**P22-15**  
**Root 18 CrossFit Addition and Parking**  
**Revised**

Property Owner: Van-Park Properties LLC  
 Applicant: Carlin Vandendriessche  
 Location: 600 West Liberty Street  
 Zoning: C-1 (Local Commercial)  
 Request: Site Plan and TC-OV approval for a building addition, building alterations, and parking expansion

3 SIDE STREET ELEVATION (EAST)  
SCALE 1/8" = 1'-0"

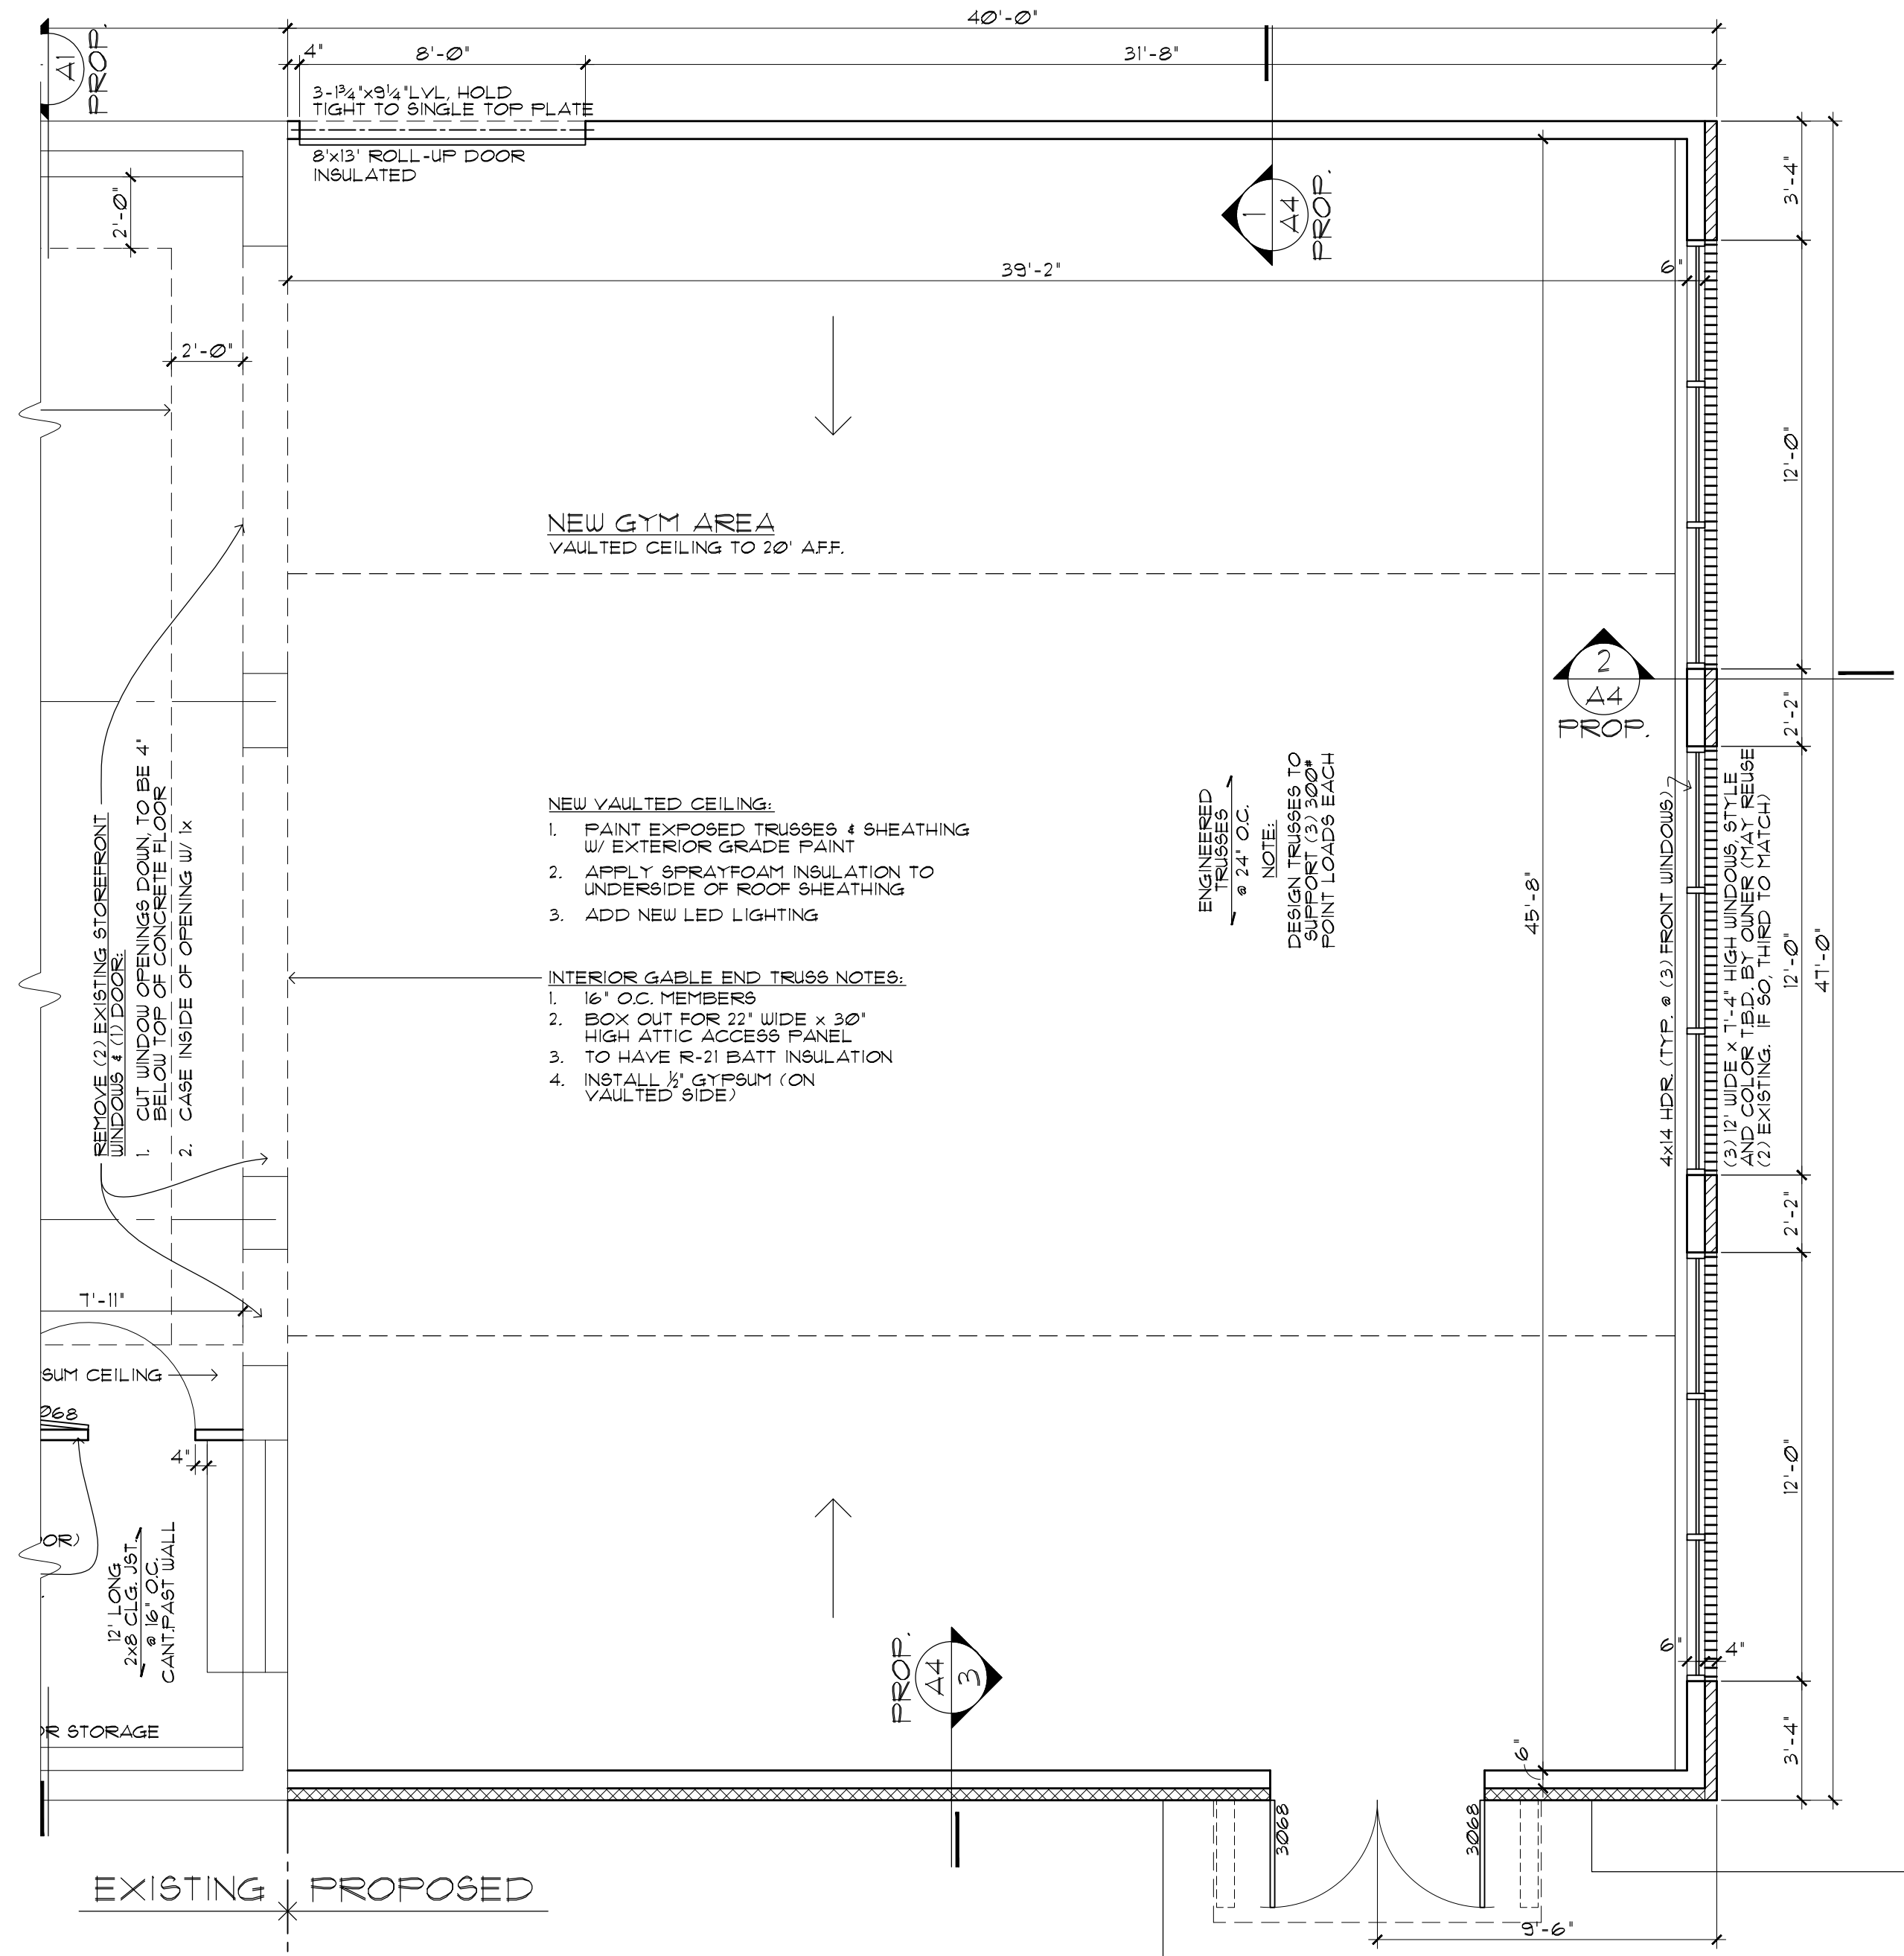
The east side of the addition will have green CMU on the lower portion and vertical metal siding on the upper portion. The east side of the addition will also have a covered entryway. An awning is also shown over an existing entry on the south side of the building elevation.

As noted, CMU's are proposed on the subject addition to be covered with an approved material. The Planning Commission has the ability to accept CMU's on all or part of the addition, or require other materials changes.
